E8363A-01C

S E R V I C E N O T E

E8363A PNA Series RF Network Analyzers

Serial Numbers: 00000000 thru 46999999

Figure 1

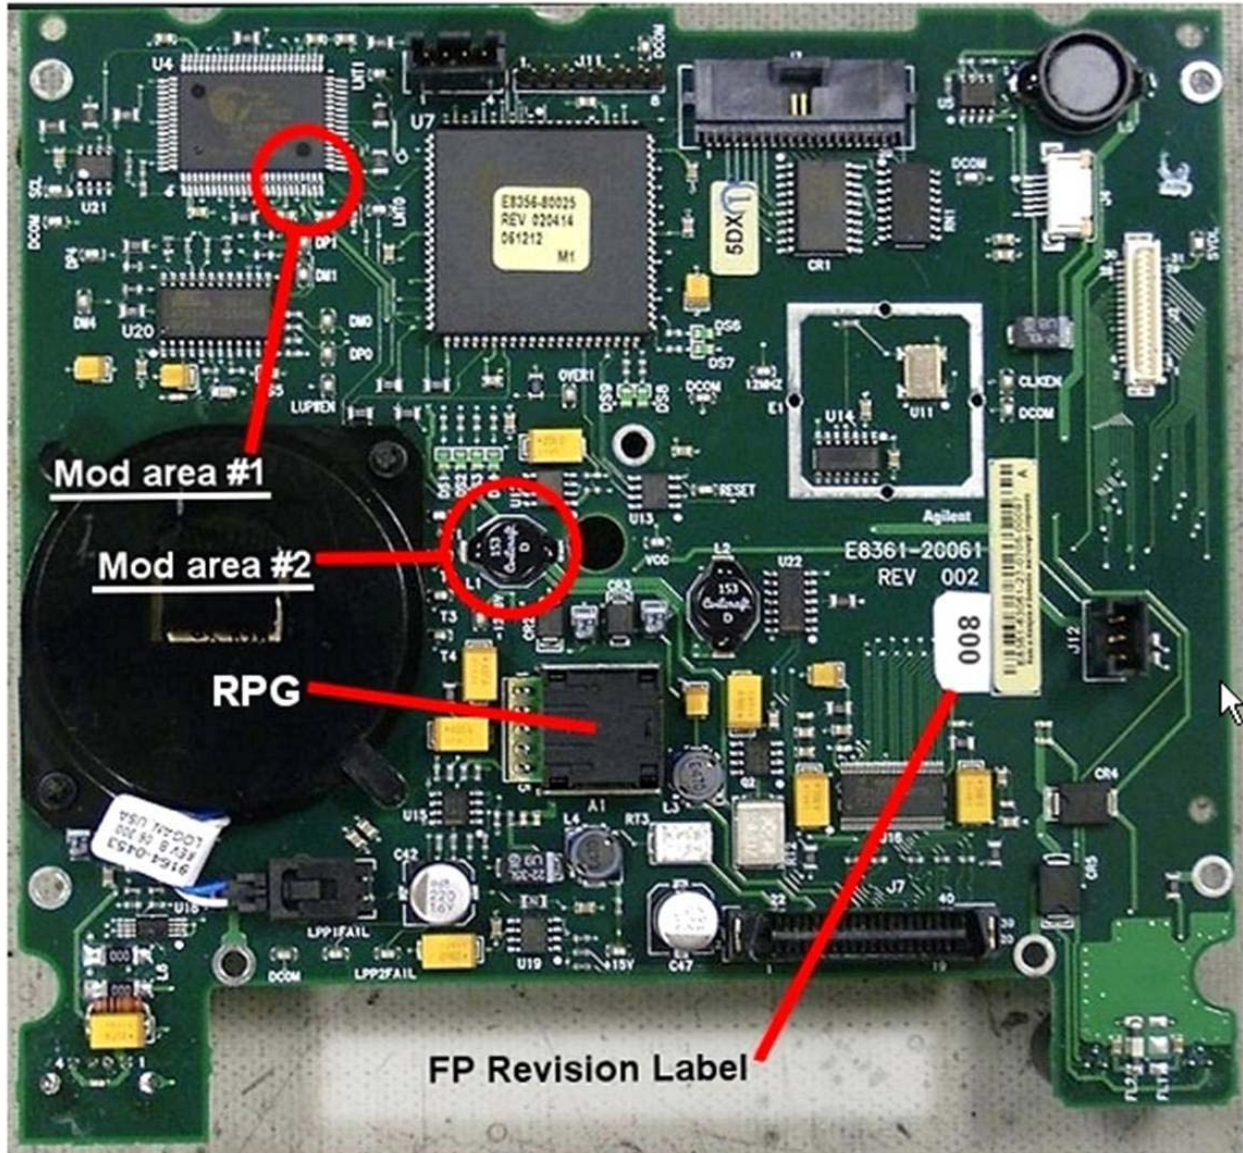
Refer to Figure 1 for the two modification areas to be addressed. Note that while this picture happens to show the FPI board completely removed from the front frame assembly, this is not necessary to perform the required modifications.

- Modification #1 consists of shorting two pins of U4 together with a small amount of solder.
- Modification #2 consist of removing L1.

Figure 2

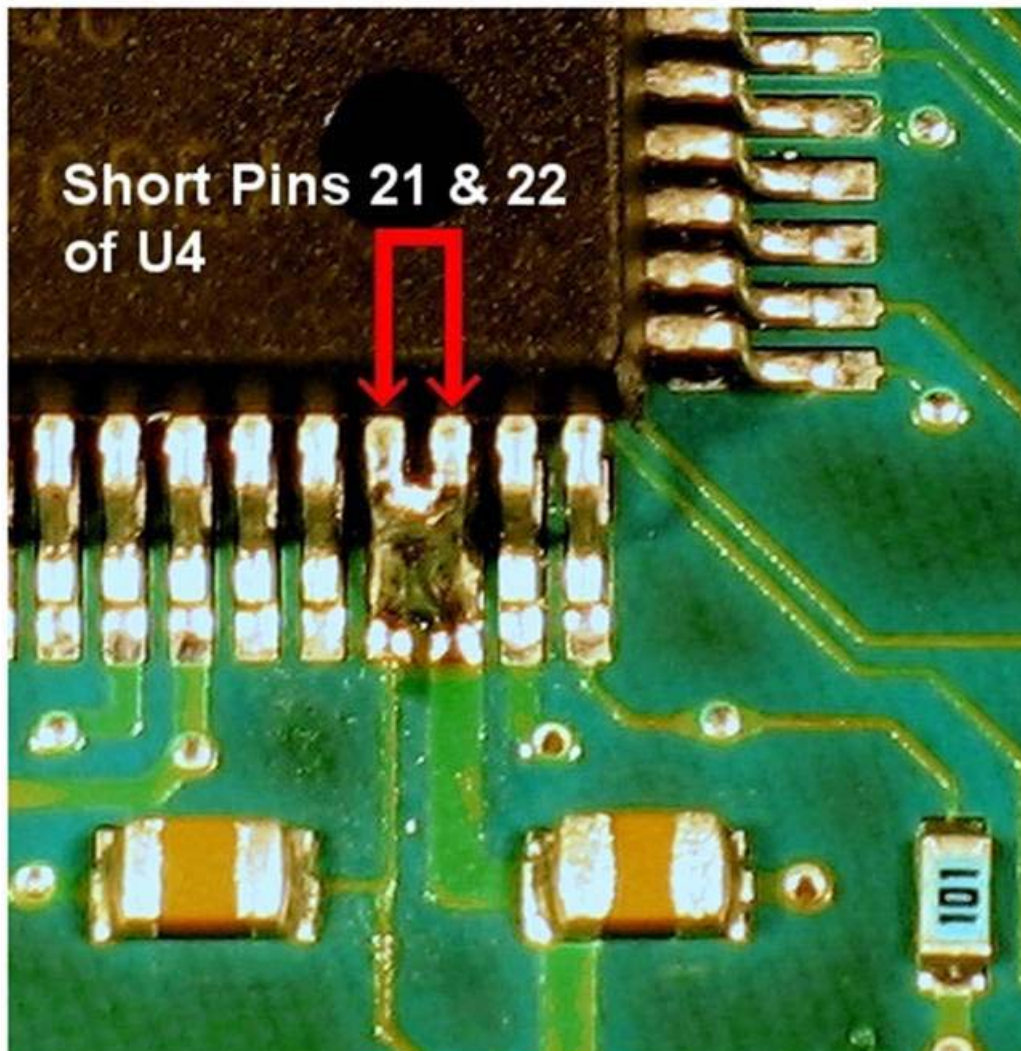
Carefully solder pins 21 and 22 together on U4. Refer to Figure 2 for the exact location. Use care so that no other pins are shorted. Use of a very fine tip soldering iron is recommended and a large work-task magnifying glass is very helpful.

Unsolder and completely remove the black surface mount inductor L1 from the front panel assembly board. This is no longer needed and can be discarded.

When the modifications have been completed, you need to change the board revision number from its existing version to version 009. You can cross off the existing revision label and write in "009" or you can create your own label to place over it.
